Device **XC878CLM Series**
Marking/Step **AC**
Package **PG-LQFP-64**

This Errata Sheet describes the deviations from the current user documentation. The module oriented classification and numbering system uses an ascending sequence over several derivatives, including already solved deviations. So gaps inside this enumeration can occur.

This Errata Sheet covers the following devices:

- XC878CM-13/16FF
- XC878CLM-13/16FF

Figure 1 FIFO structure

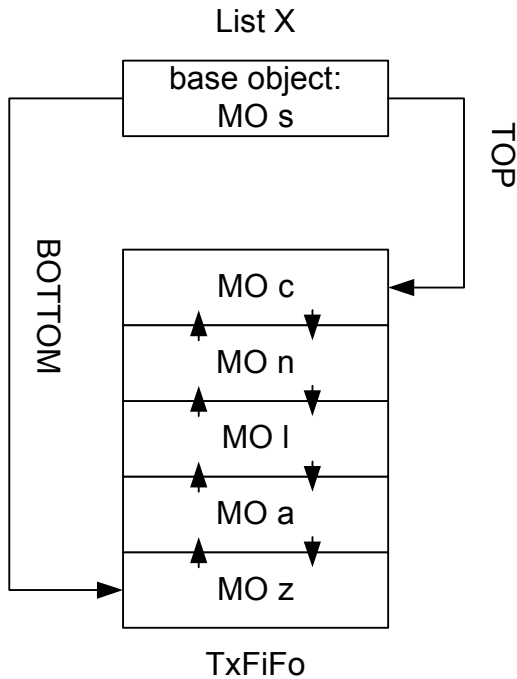
MultiCAN_TC.029 Tx FIFO overflow interrupt not generated

Real behaviour

A Tx FIFO overflow interrupt will not be generated after the transmission of the Tx FIFO base object.

If Tx FIFO overflow interrupt needed, take the FIFO base object out of the circular list of the Tx message objects. That is to say, just use the FIFO base object for FIFO control, but not to store a Tx message.

Figure 3 Counting sequence of T12 in center-aligned mode

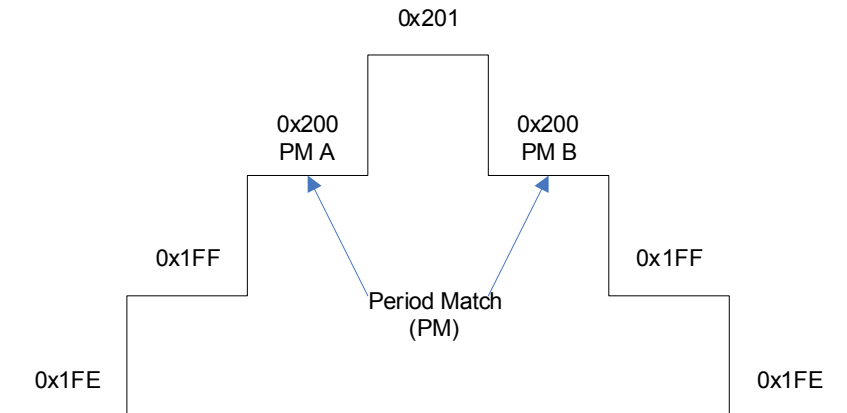
After detecting a period match (PM A) in centre-aligned mode, T12 counts down from PM + 1 as shown below:

This means a second PM event (PM B) will occur during the counting down. If ADC is triggered externally via ETRx2 (T12PM), it will be triggered twice in succession. Depending on how real-time the application code is running as well

as the T12 count rate and ADC conversion rate, the application could observe two ADC interrupts - once at PM A and once at PM B.

To avoid triggering twice the ADC interrupts, it is suggested to use ETRx6 from multi-channel mode instead of ETRx2 as the trigger source for ADC. Additional initialization are as follows:

- Configure MCMCTR.SWSEL = 101_B (Transfer on T12 period match)
- Configure MCMCTR.SWSYN = 00_B (Direct transfer)
- Write to MCMOUTSTL = CF_H (To enable multi-Channel PWM pattern on CC6x and COUT6x)

Figure 4 Noise Immunity Enhancement Circuitry

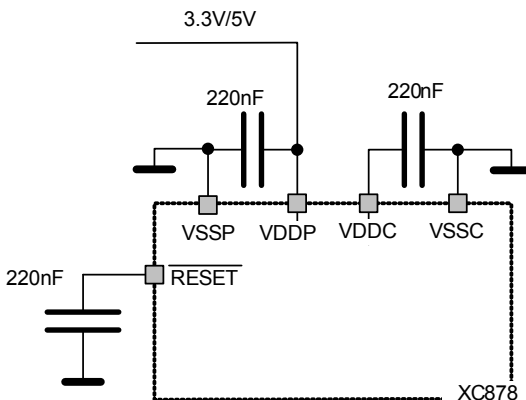
EVR_XC8.H002 Enhancement for Noise Immunity

During power up, the EVR functionality may be affected due to injected noise from any functional pin. In order to enhance the noise immunity, the external reset pin RESET must be asserted until VDDC reaches $0.9 * VDDC$. The delay of external reset can be realized by an external capacitor at RESET pin. This capacitor value must be selected so that VRESET reaches 0.4 V, but not before VDDC reaches $0.9 * VDDC$.

A typical application example is shown in **Figure 4**. A 220 nF capacitor is connected to VDDP pin, VDDC pin and RESET pin. In addition, it is also essential to put it as close as possible to the chip.

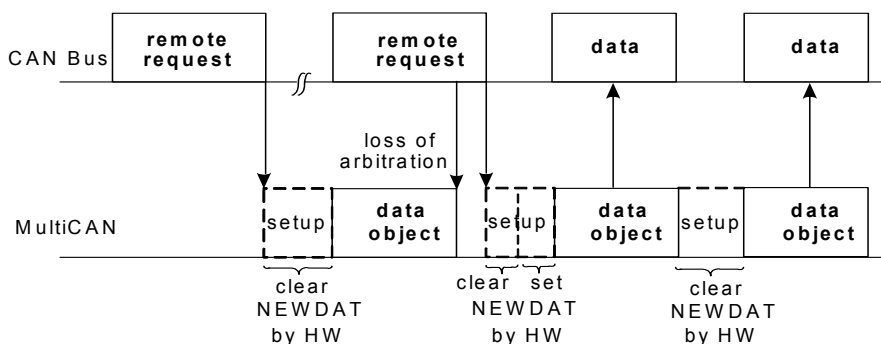
MultiCAN_TC.H003 Message may be discarded before transmission in STT mode

If $MOFCR_n.STT=1$ (Single Transmit Trial enabled), bit TXRQ is cleared (TXRQ=0) as soon as the message object has been selected for transmission and, in case of error, no retransmission takes places.

Therefore, if the error occurs between the selection for transmission and the real start of frame transmission, the message is actually never sent.

In case the transmission shall be guaranteed, it is not suitable to use the STT mode. In this case, $MOFCR_n.STT$ shall be 0.
